SAFETY EVALUATION BY THE OFFICE OF NUCLEAR REACTOR REGULATION
RELATED TO DENIAL OF AMENDMENT TO FACILITY OPERATING LICENSE

NO. DPR-63

NINE MILE POINT NUCLEAR STATION UNIT NO. 1

DOCKET NO. 50-220

FIGURE 1

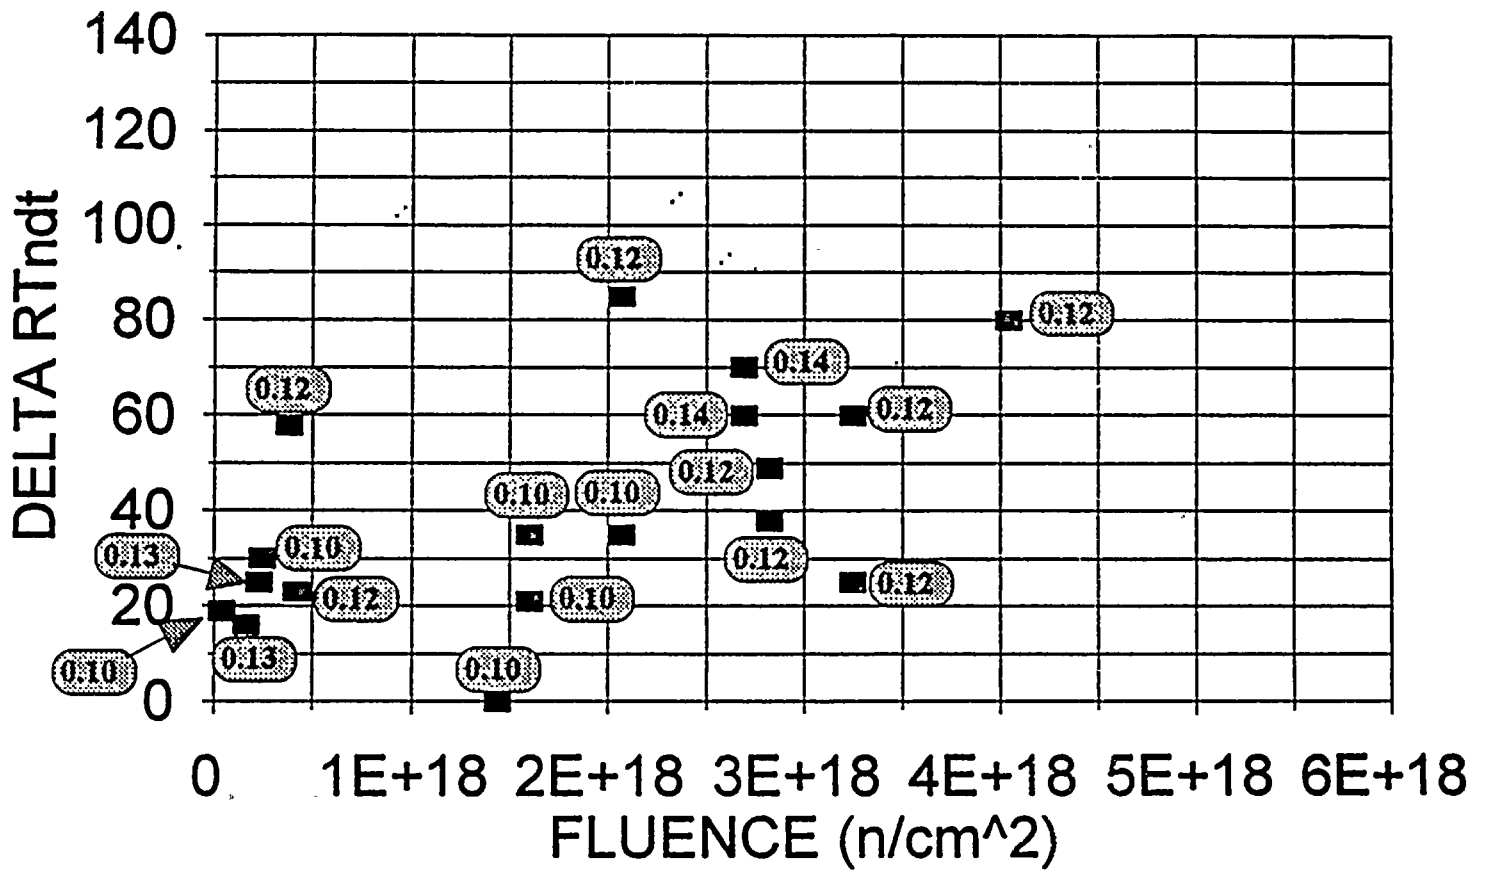
The staff generated graphs of ΔRT_{NDT} vs. fluence as shown in attached Figures 1, 2, and 3. The graphs represent all of the data used in the licensee's regression analysis. Figure 1 represents low (0.10%-0.15%) copper values, Figure 2 intermediate (0.15%-0.20%) values, and Figure 3 high (0.20% and above) values. With a few exceptions, the data do not support the licensee's contention that at fast neutron fluences as high as $2E18$ n/cm², there is no significant copper functional dependence in the Charpy shift model. In contrast, the data show that for high ranges of percent copper, higher copper contents result in higher values of ΔRT_{NDT} .

With respect to copper dependence, the data used in the regression analysis do not support the licensee's contention that at fast neutron fluences as high as $2E18$ n/cm², there is no significant copper functional dependence in the Charpy shift model. In contrast, the data show that for high, intermediate, and low ranges of percent copper, higher copper contents result in higher values of ΔRT_{NDT} .
